Texas Utilities Services Inc.
Comanche Peak Steam Electric Station
1980-1982 Units 1 and 2
CPSES SSI Dam
Design Calculation Checks

SAFE SHUTDOWN IMPOUNDMENT DAM
DESIGN CALCULATIONS AND CALCULATIONS CHECK

MEMORANDUM:

RE: Independent Review of Calculations
Texas Utilities Services, Inc., - SSI Dam

Title: SQUAW CREEK RESERVOIR
DISCHARGE RATING - 100' ogee

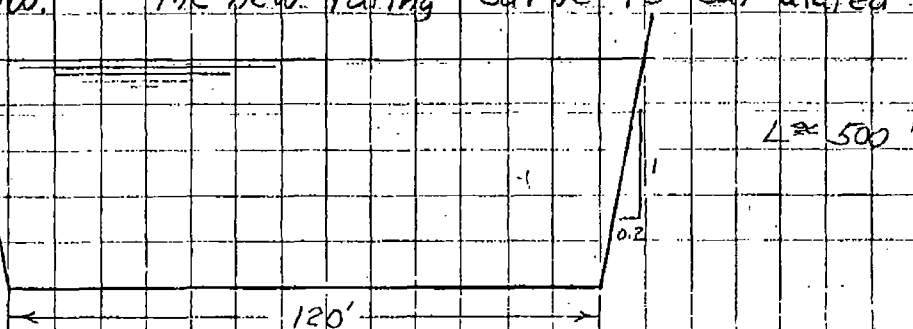
The approach channel configuration was changed as shown below. The new rating curve is calculated to compare.

Only two points were different from original values & these were
only by 0.1 ft, so no change was made in rating curve.

Fig. 5-6. Slope protection nomograph for dumped riprap for earth dams

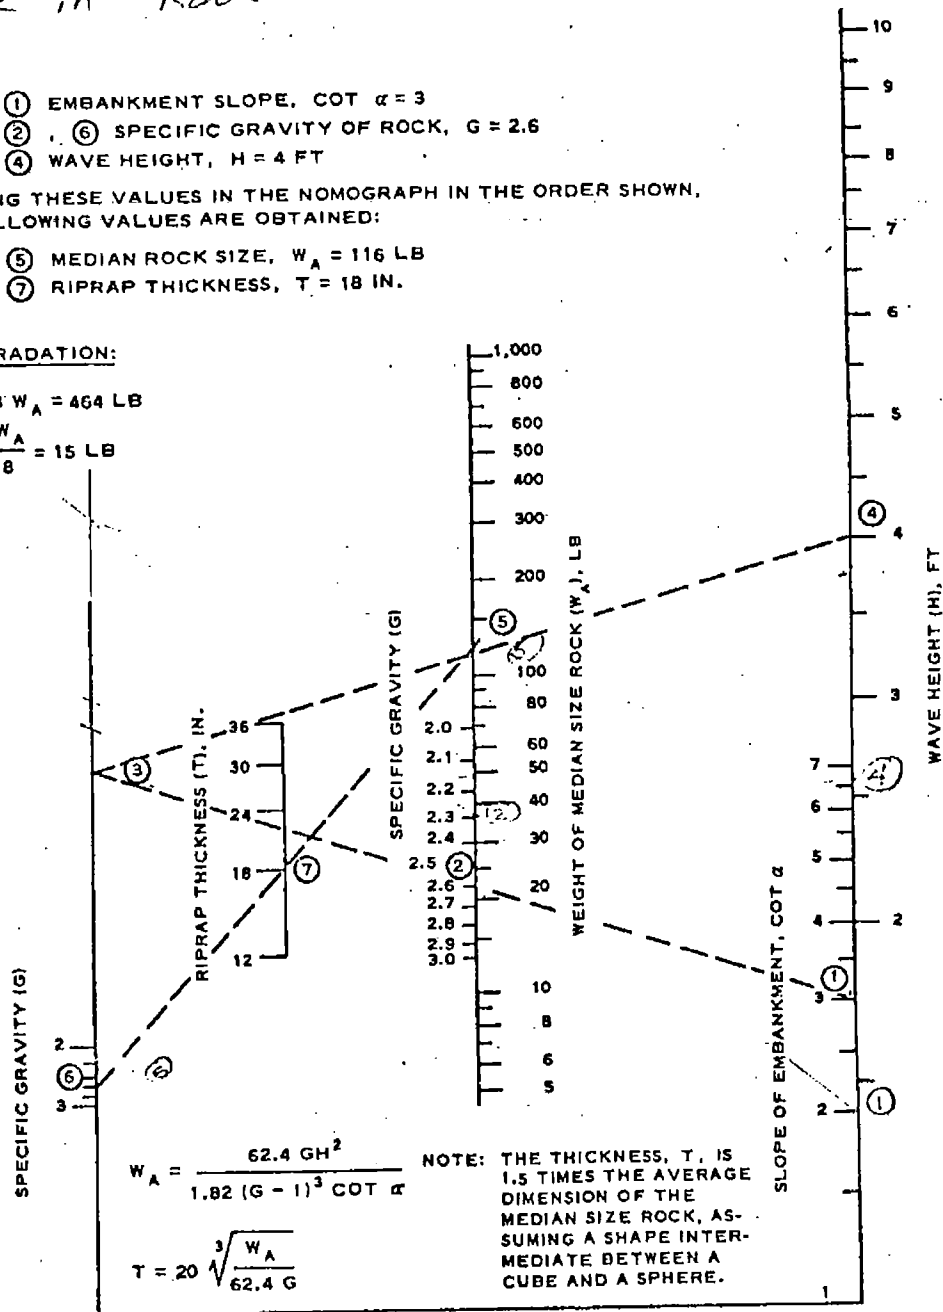
Using the figure the riprap thickness is 19". The use of 24" is therefore conservative. This thickness is 1.5 times the avg. diameter of the median size rock.

Spillway Rating -
Independent Check

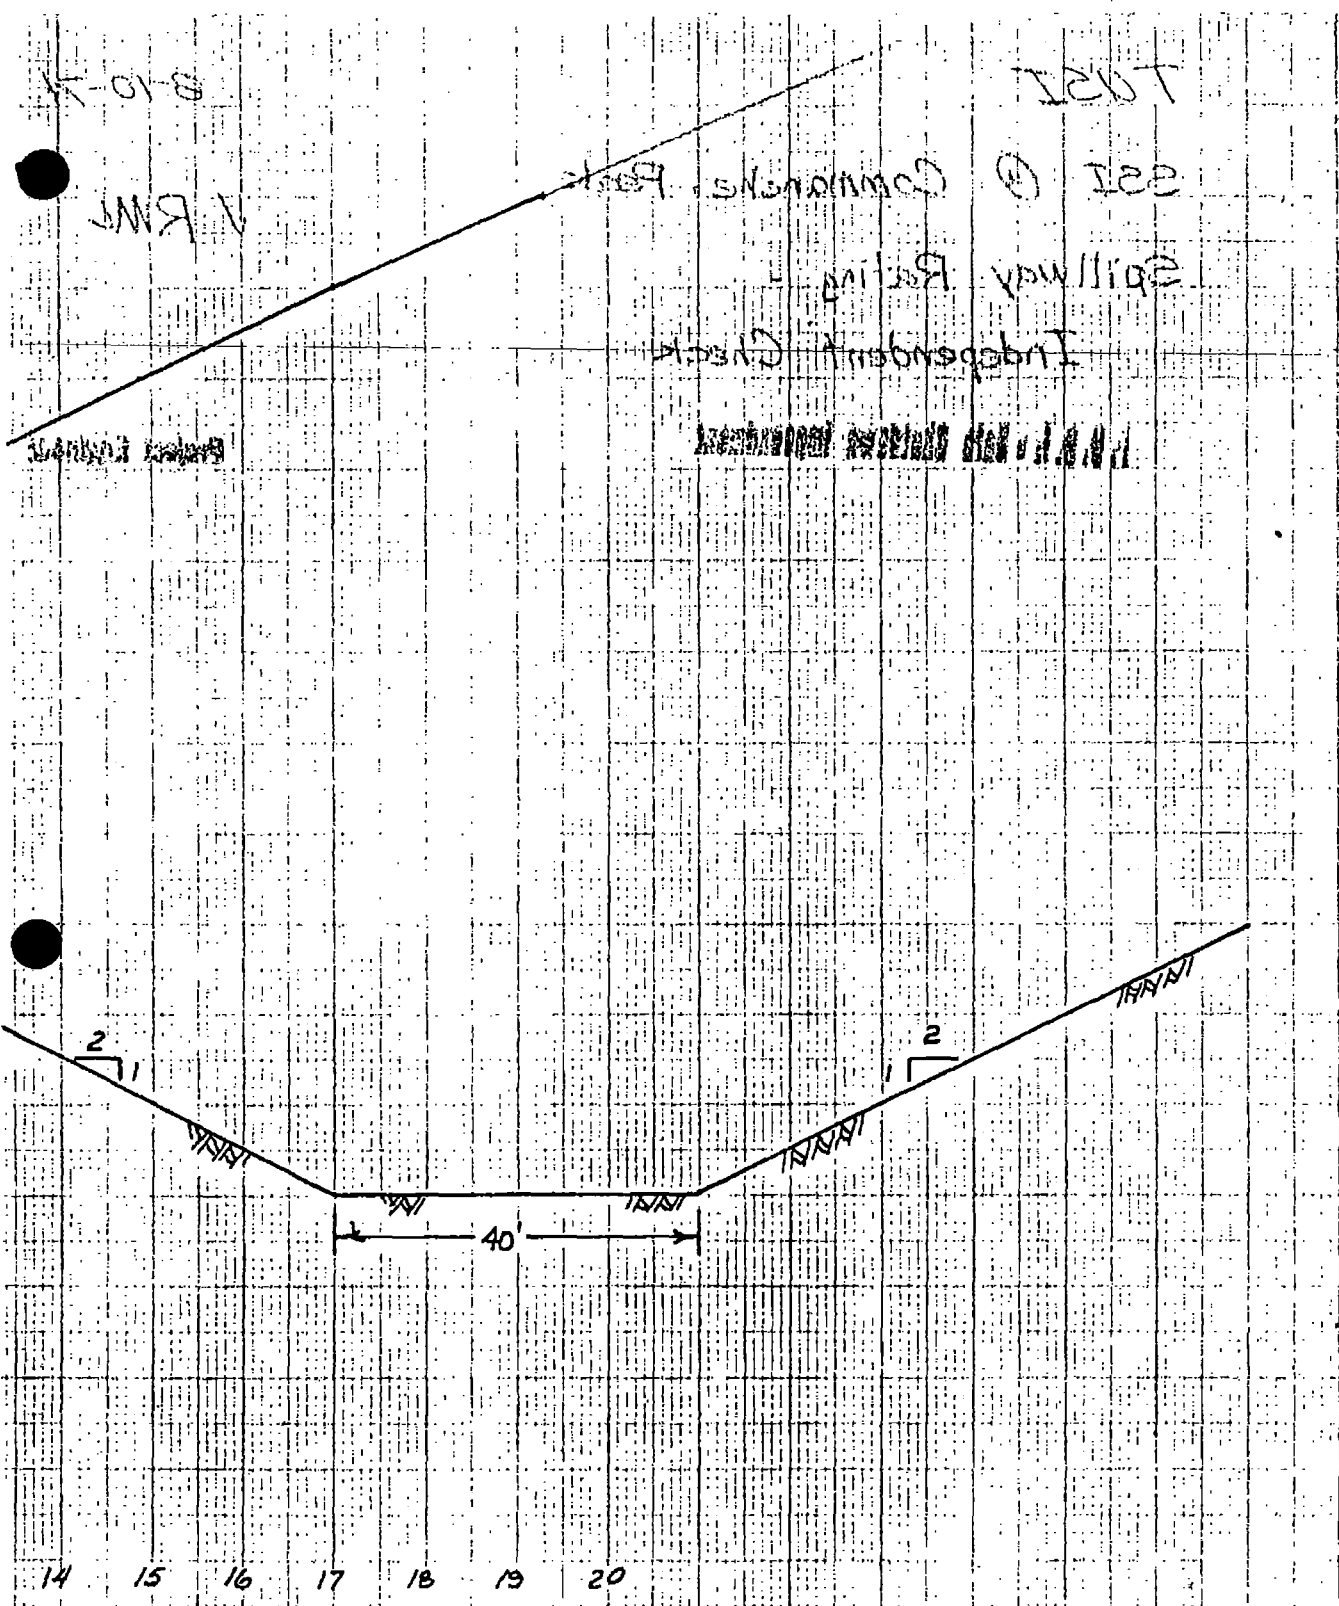
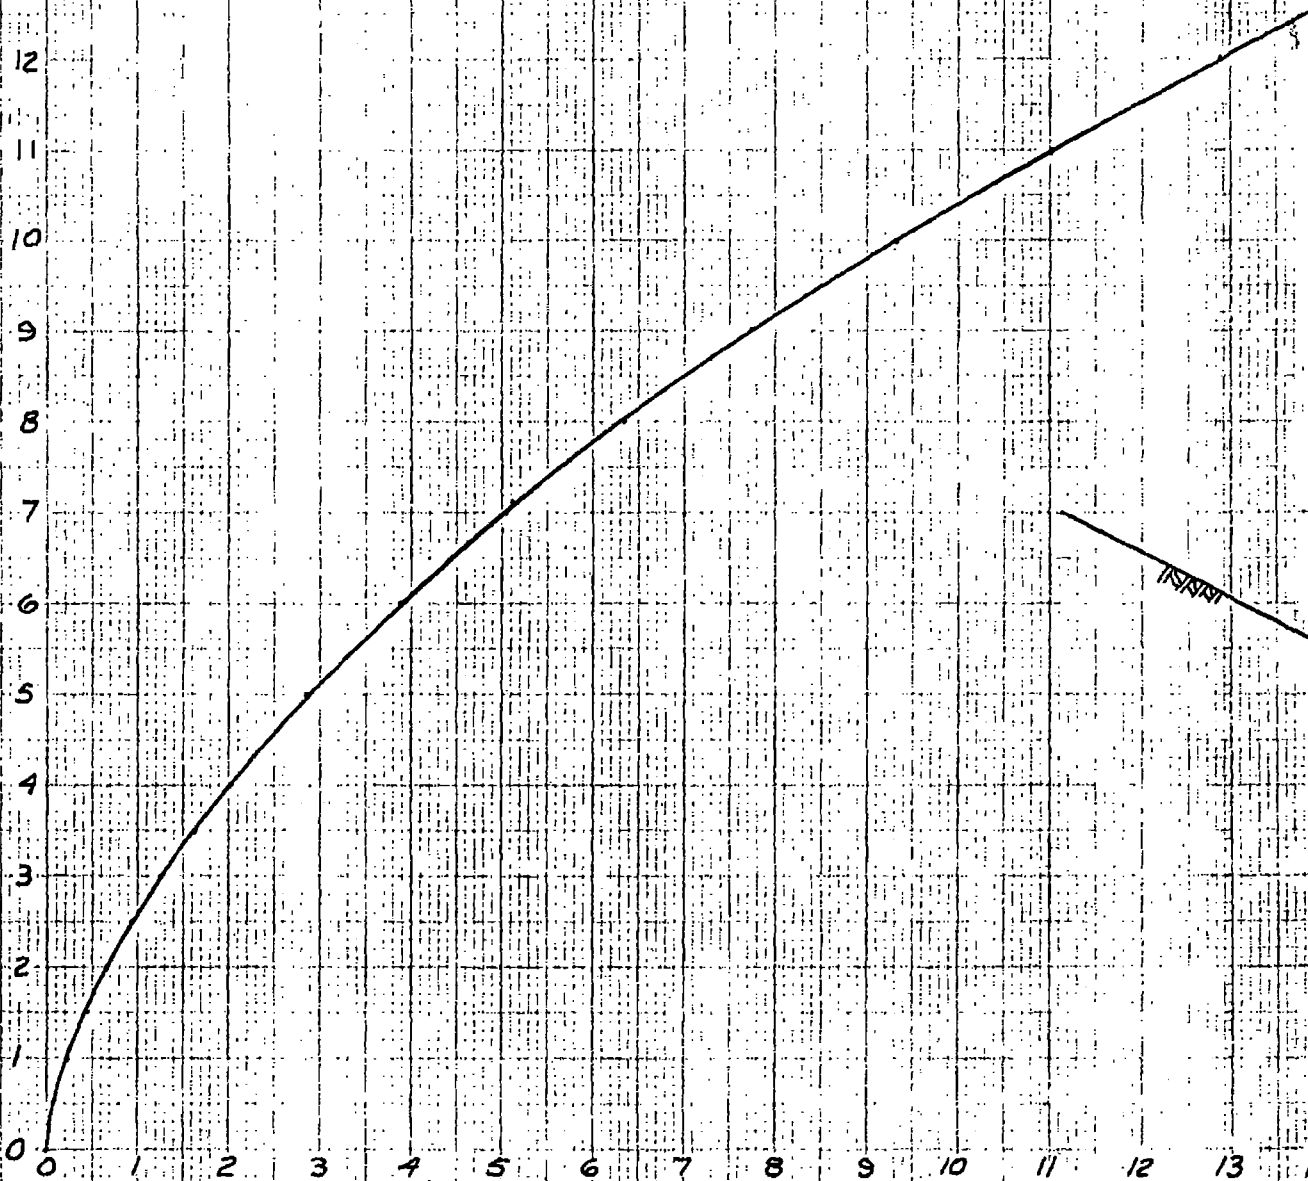
The water surface in the SSI is determined for varying discharges and varying water surface elev. in the SCR using the above described methods. The results thus obtained could be 0.1 foot off because of truncation. This still exceeds the accuracy of the actual results. The distance between (1) and (3) in Figure I is an estimated average distance which will vary with the water surface elevations. The estimate is made using the profile referred to in (1) a.

The graph obtained is very similar to the original. The ^{maximum} variation is in the order of 0.1' to 0.2' so no change in the original is justified.
